Piper Aircraft, Inc.
2926 Piper Drive
Vero Beach, Florida, U.S.A. 32960

SERVICE BULLETIN

NO. 1266

FUEL WARNING PLACARD AND POH INSPECTION

Figure 1
Warning Placard - PA-24-250 (FI), PA-24-260 (FI), PA-24-260 "C" and PA-24-400 Comanche

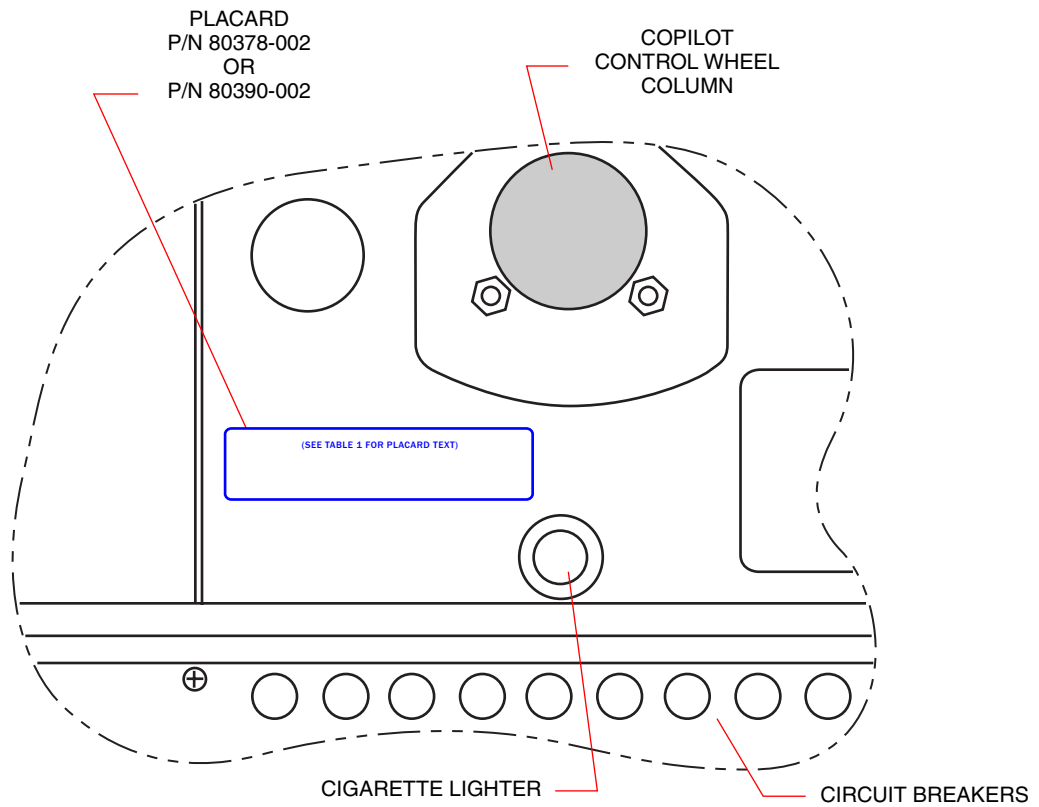
WARNING PLACARD, LOWER RIGHT SIDE OF INSTRUMENT PANEL

| PLACARD PART NUMBER | PLACARD TEXT SHOWN IN LIMITATIONS SECTION OF THE POH |
|----------------------------|--|
| 80378-002 | WARNING — UNCOORDINATED MANEUVERS, INCLUDING SIDE SLIPS OF 30 SECONDS OR MORE, FOR ANY REASON, AND FAST TAXI TURNS JUST PRIOR TO TAKEOFF CAN CAUSE LOSS OF POWER IF FUEL TANK IN USE IS LESS THAN 1/2 FULL |
| 80390-002 | WARNING — UNCOORDINATED MANEUVERS, INCLUDING SIDE SLIPS OF 30 SECONDS OR MORE, FOR ANY REASON, AND FAST TAXI TURNS JUST PRIOR TO TAKEOFF CAN CAUSE LOSS OF POWER IF FUEL TANK IN USE IS NOT FULL |

Figure 2
Warning Placard - PA-31 and PA-31-300

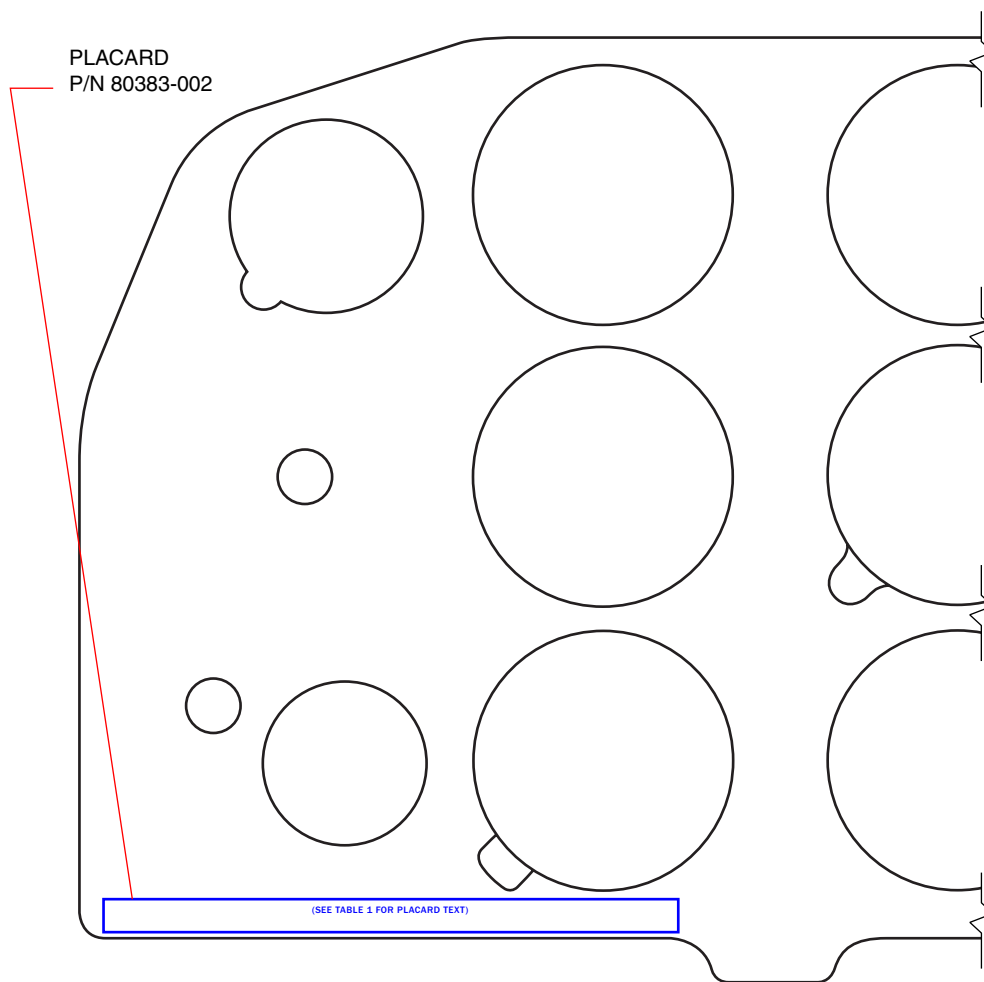
WARNING PLACARD, LOWER LEFT CORNER OF LEFT INSTRUMENT PANEL

| PLACARD PART NUMBER | PLACARD TEXT SHOWN IN LIMITATIONS SECTION OF THE POH |
|----------------------------|--|
| 80383-002 | WARNING — UNCOORDINATED MANEUVERS, INCLUDING SIDE SLIPS OF 30 SECONDS OR MORE, FOR ANY REASON, AND FAST TAXI TURNS JUST PRIOR TO TAKEOFF CAN CAUSE LOSS OF POWER IF FUEL TANKS IN USE ARE LESS THAN 3/4 FULL |

Figure 3
Warning Placard - PA-31P Navajo

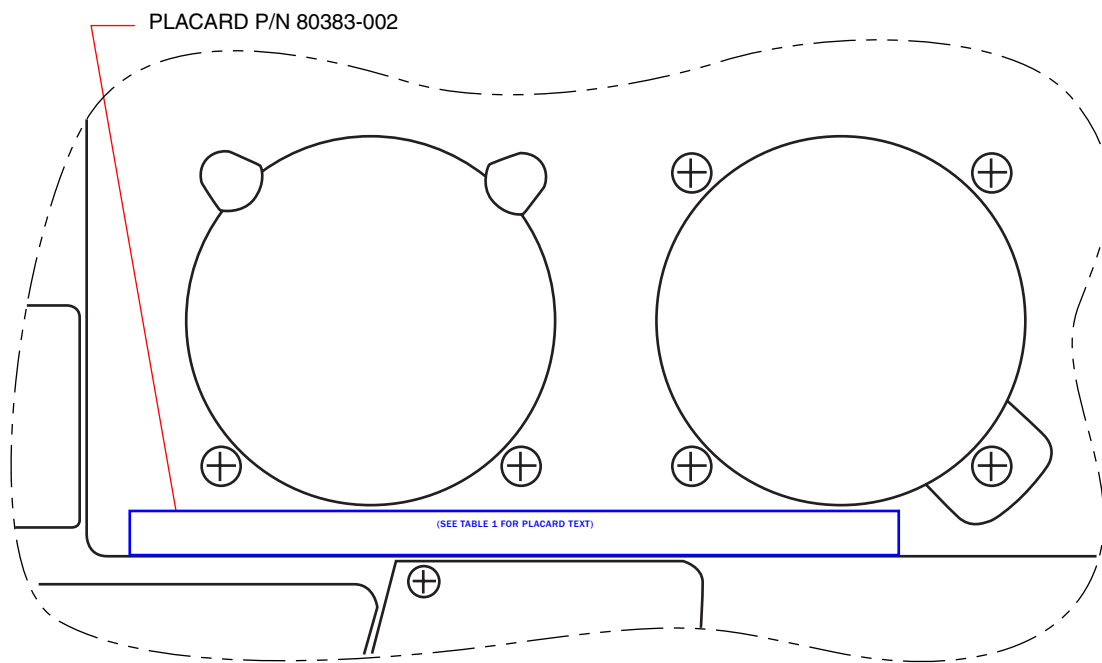
WARNING PLACARD, LOWER LEFT CORNER OF MAIN INSTRUMENT PANEL

Figure 4
Warning Placard - PA-23-250 and 23E-250 Aztec (six-place) "B," "C," "D," and "E"

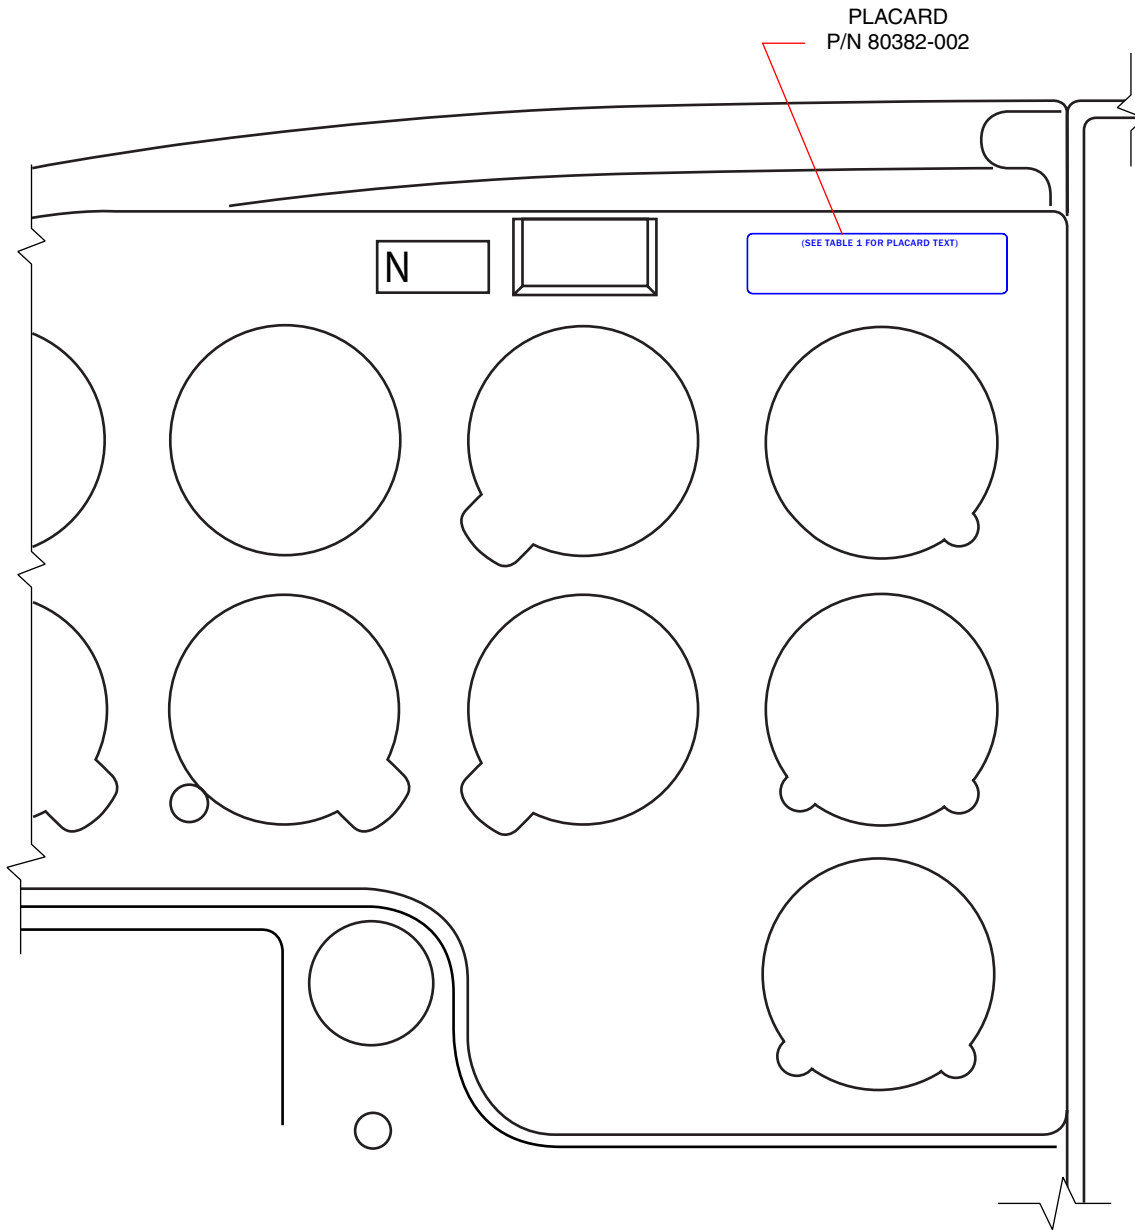
WARNING PLACARD, UPPER LEFT INSTRUMENT PANEL,
ADJACENT TO THE COMPASS DEVIATION CARD
AZTEC "E" SHOWN

| PLACARD PART NUMBER | PLACARD TEXT SHOWN IN LIMITATIONS SECTION OF THE POH |
|----------------------------|--|
| 80382-002 | WARNING — UNCOORDINATED MANEUVERS, INCLUDING SIDE SLIPS OF 30 SECONDS OR MORE, FOR ANY REASON, AND FAST TAXI TURNS JUST PRIOR TO TAKEOFF CAN CAUSE LOSS OF POWER IF FUEL TANKS IN USE ARE LESS THAN 1/2 FULL |
